# Administrative Approval Action

Case File / Name: ASR-0056-2022 DSLC - 330 W HARGETT City of Raleigh
Development Services Department
One Exchange Plaza
Raleigh, NC 27602
(919) 996-2492
currentplanning@raleighnc.gov
www.raleighnc.gov

**REQUEST:** Development of a mixed use building including residential, retail, restaurant along

approval being met, conforms to the Unified Development Ordinance. This approval is based on a preliminary plan dated June 26, 2023 by Stewart

## TRANSPARENCY CALCULATION

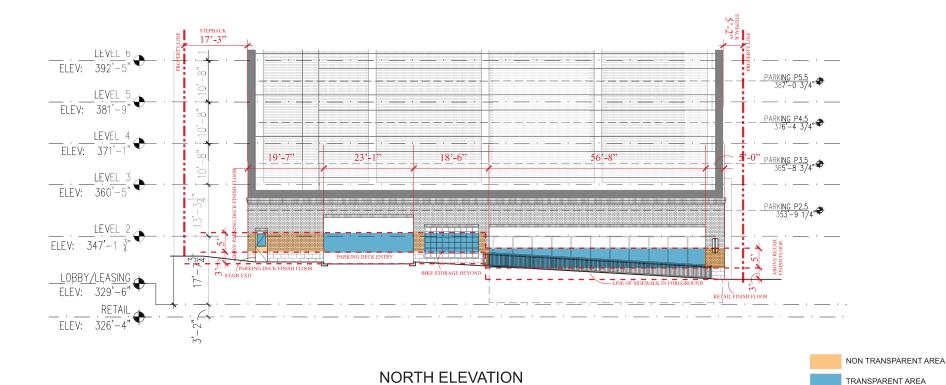
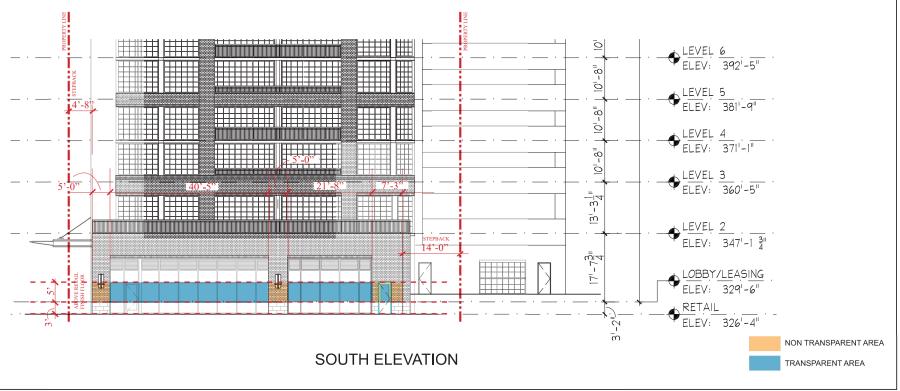
All street facing facades must meet the minimum (ground floor minimum transparency = 66% between 0-12' in DX zoning)(3.2.6). (Transparency is n/a on residential floors). . (1.5.9 and 3.2.6) Please correct/revise calculations at the tops of the last three sheets - elevations/66% transparency proposed. See correct sheets

(A6-01, A6-03, and A6-05) of version 3 of preliminary submittals.
